Crystal River Nuclear Plant
Docket No. 50-302
Operating License No. DPR-72

July 19, 2007
3F0707-05

Subject: Crystal River Unit 3 – License Amendment Request #292, Revision 1: Additional Storage Patterns for Crystal River Unit 3 Storage Pools A and B and Response to Request for Additional Information (TAC No. MD3308)

Figure 5.3 (detail): Detail of a Two-Dimensional Representation of the Actual Calculation Model Used for the Pool B Rack Analysis for Loading of Fresh Fuel Surrounded by Empty Storage Cell Locations

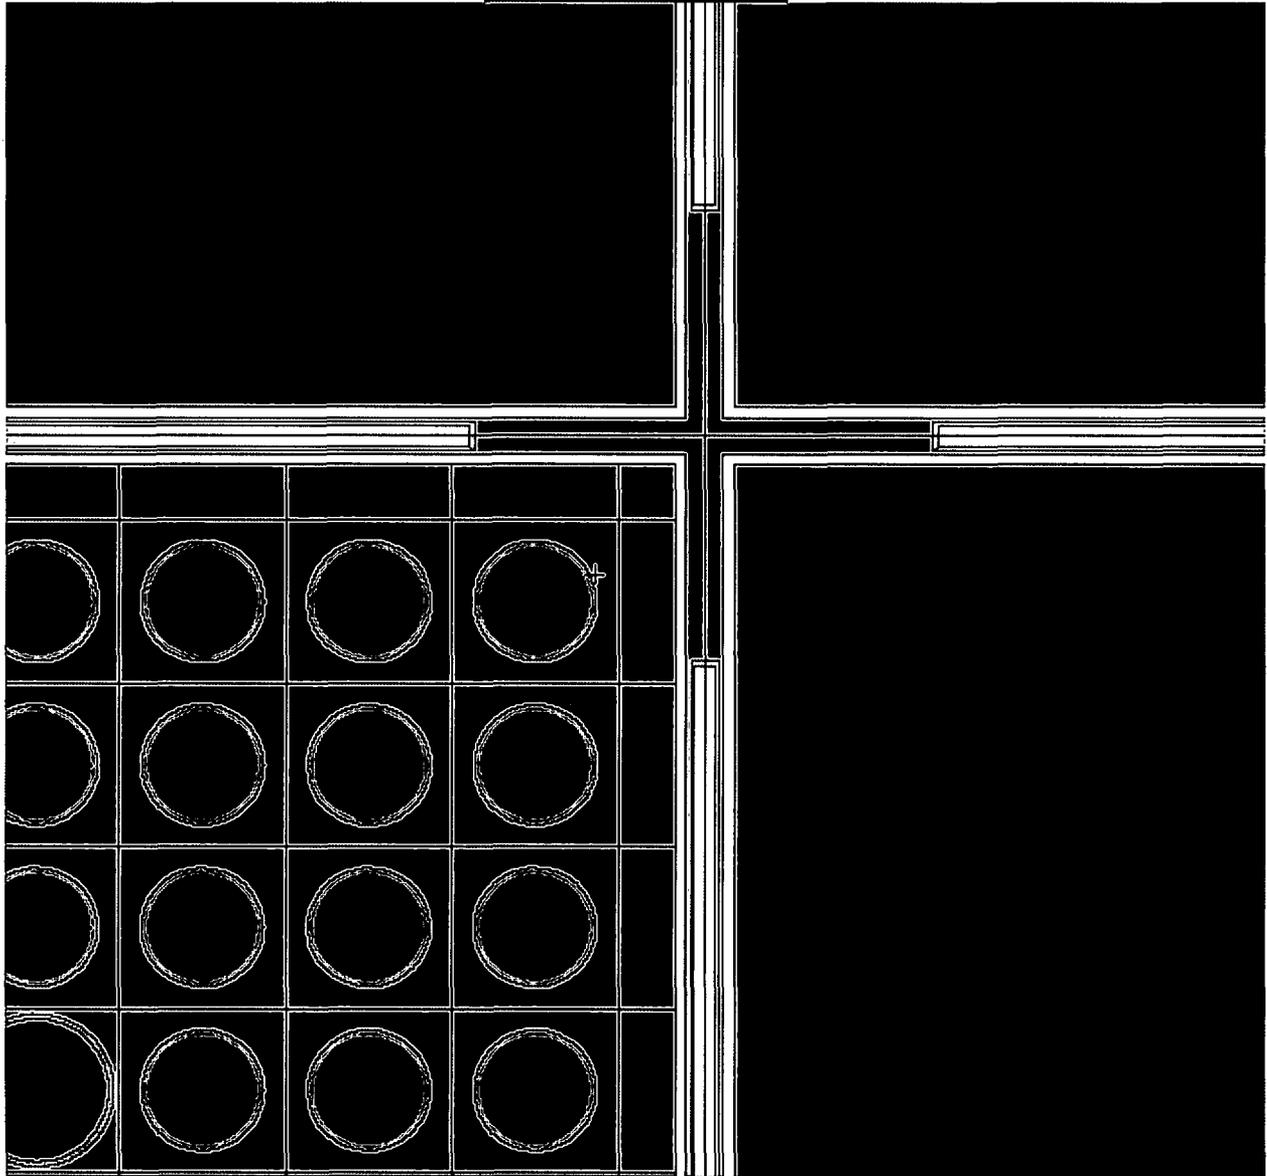
10e. Boral's stainless steel sheathing cannot be discerned on Figure 5.3. Describe how the sheathing is modeled.

- 20. HI-2063579 Section 7.3.4 describes the development of maximum k_{eff} for Pool B. The model used for the analysis is shown in Figures 5.3 and 5.4. Figure 5.4 is a representative sketch of the storage cell. Figure 5.3 is a drawing representative of a fresh fuel assembly bordered by eight empty storage cells, which in turn are bordered by Category B fuel assemblies.**
- 20a. Figure 1.2 shows two arrangements of a fresh fuel assembly bordered by eight empty storage cells bordering each other and not separated by four rows of**

10e. *Figure 5.3 in Reference 7 has been reproduced at a greater resolution and magnification to show the modeling of the Boral sheathing. This information is shown in Figure 5.3 (detail) on page 24 of this attachment.*

18b. The combinations of burnups and enrichments for the spent fuel assembly in the configuration shown in Figure 5.3 of Reference 7 (see also Figure 5.3 (detail) on page 24 of this attachment) are shown in Table 5.9 of Reference 7 for Category B fuel. The spent fuel assembly is based on the Mark B-10F fuel assembly, which is shown to be the bounding assembly for Category B fuel in Table 7.4 of Reference 7. The fresh fuel assembly is based on the Mark B-11 fuel assembly, which is shown to be the bounding assembly for fresh fuel in Table 7.4. The uncertainties presented in Table 7.10 of Reference 7 are the bounding uncertainties for the Figure 5.3 configuration of fresh fuel with surrounding spent fuel having an initial enrichment of 5.0 weight percent with a

21c. Correct. Figure 5.3 is the correct model for the misloading accident in Pool B except for the presence of the misloaded assembly which is not shown in the figure.

Figure 3.7.15-1
Burnup versus Enrichment Curve for
Spent Fuel Storage Pool A

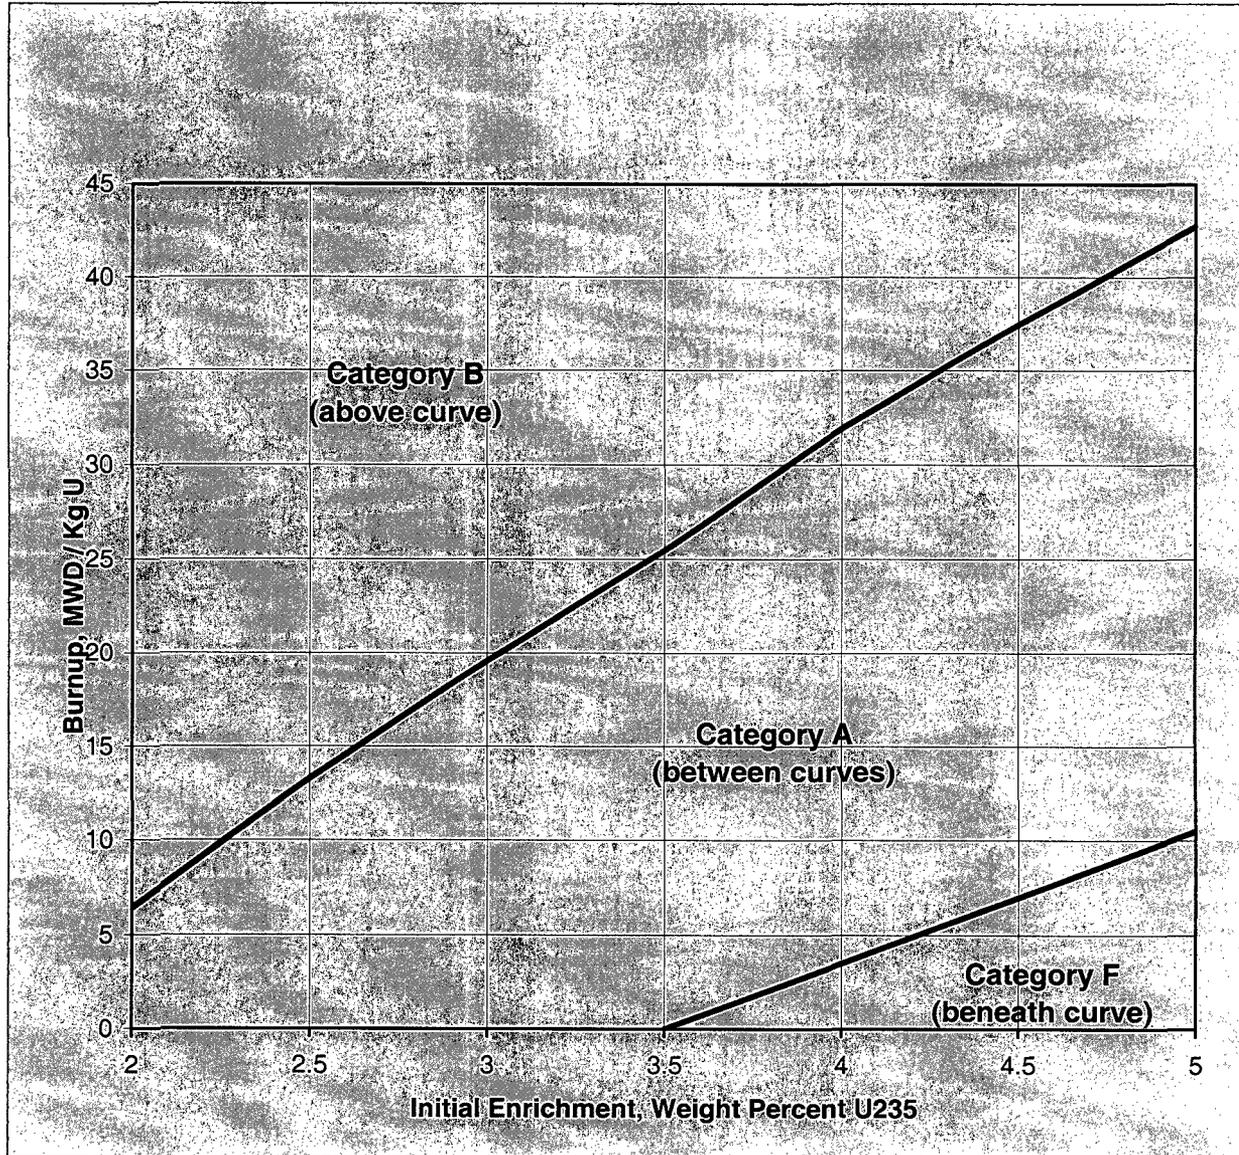
A similar revision was made to Figure 3.7.15-1 to acknowledge the storage restrictions identified in Note 3 of that figure.

1. Category B: Fuel from this category can be stored with no restrictions except as noted below.
2. Category A: Fuel from this category can be stored with fuel from Categories A or B.
3. Category F: Fuel from this category must be stored in a one-out-of-two checkerboard configuration with fuel from Category B or empty water cells. Category F fuel stored in a checkerboard pattern with either Category B fuel or empty water cells must be separated from Category A fuel by a transition row of Category B fuel.

Figure 3.7.15-2
Burnup versus Enrichment Curve for
Spent Fuel Storage Pool B

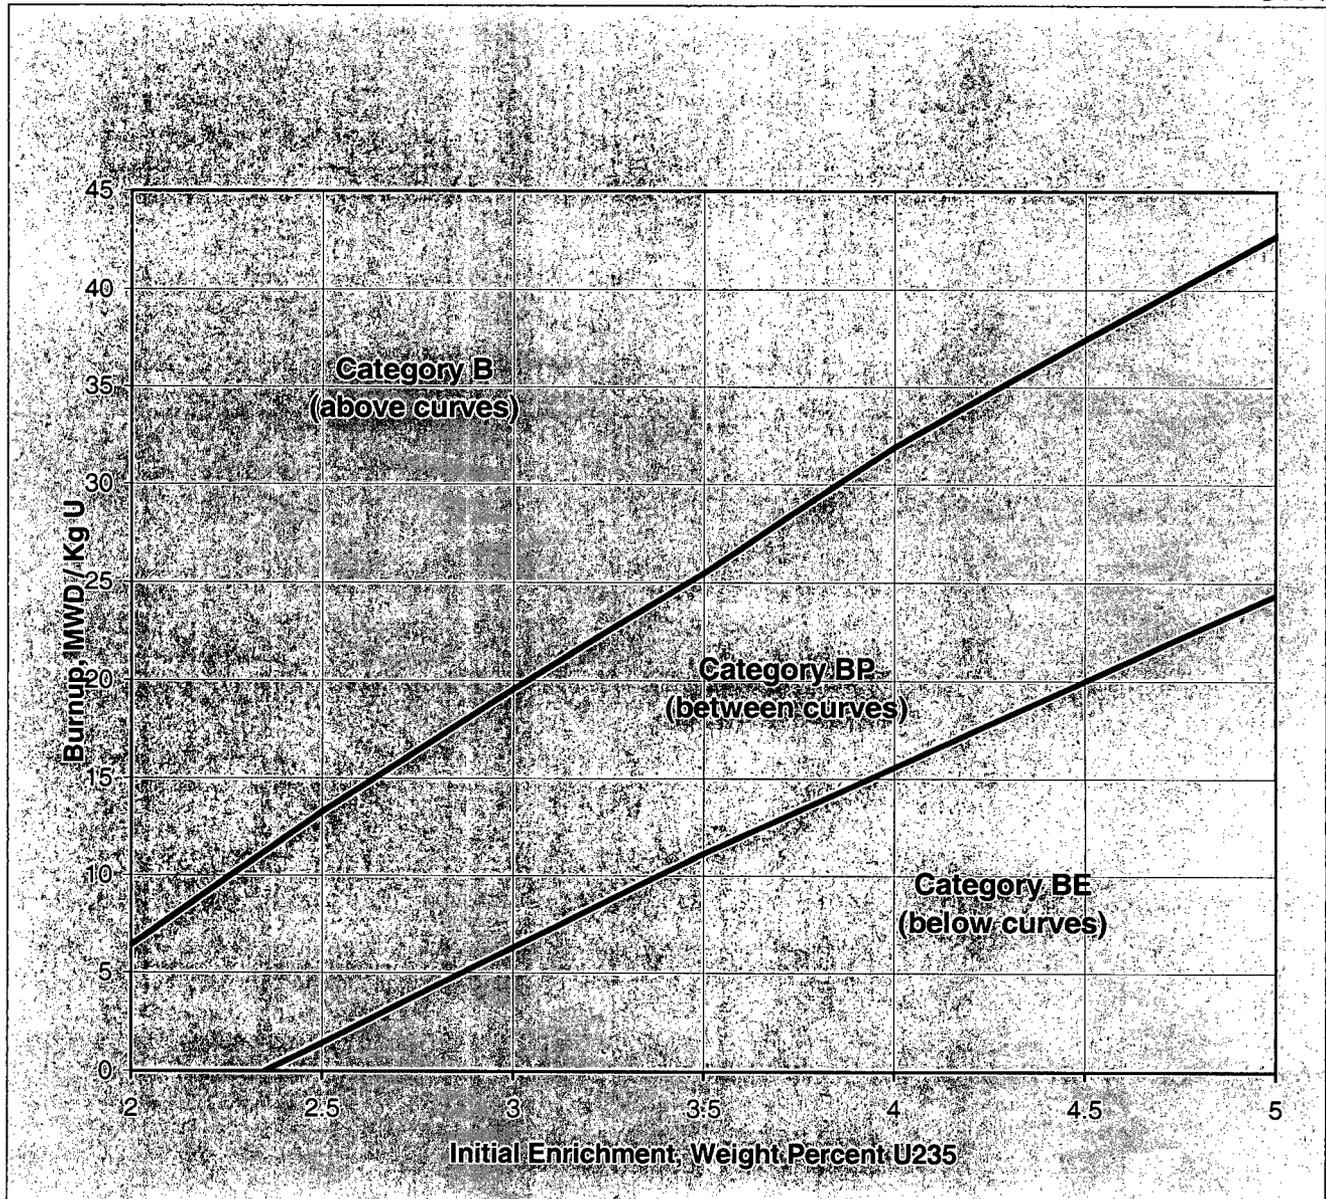
- 3. Proposed TS Figure 3.7.15-2 lists the enrichment/burnup curves for determining storage configuration requirements in CR-3 Pool B. With respect to Figure 3.7.15-2, please provide the following information:**
- 3a. The LAR has named all areas on Figures 3.7.15-1 and 3.7.15-2, except the area under the lowest curve on Figure 3.7.15-2. Why was this area not named?**

- 3b. Note 1 to Figure 3.7.15-2 states Category B fuel may be stored in any location without restriction. Note 3 to Figure 3.7.15-2 states fuel meeting the lower curve criteria can only be stored in Pool B if surrounded by eight empty water cells. Please provide clarification on this apparent contradiction, as Category B fuel assemblies cannot be stored in those empty storage cells.**

- 3c. Note 2 to Figure 3.7.15-2 states, Category BP fuel may be stored in peripheral cells. The definition of peripheral cells has been changed from the cells against the SFP wall to the last cell containing fuel. The last cell containing fuel could be in the middle of the SFP. Are there any restrictions on how far from the SFP wall a cell can be and still be considered a peripheral cell?**

- 3a. Naming of the various regions of the graph with respect to the curves was simply a designation convenience and had not been considered necessary for the region below both curves in Figure 3.7.15-2. Category F was used for the low burnup/high enrichment region in Figure 3.7.15-1, and no name was used for the low burnup/high enrichment*

region in Figure 3.7.15-2. For consistency in labeling, the region of the graph below the curves in Figure 3.7.15-2 is now identified as Category BE.

1. Category B: Fuel from this category can be stored with no restrictions except as noted below.
2. Category BP: Fuel from this category (between lower and upper curves) can be stored in the peripheral cells of the pool.
3. Category BE: Unacceptable for storage unless surrounded by eight empty water cells. Fuel of any enrichment and burnup, including fresh, unburned fuel may be stored in Pool B if surrounded by eight empty water cells. Category BE fuel assemblies must be separated by two adjacent empty cells in Pool B.
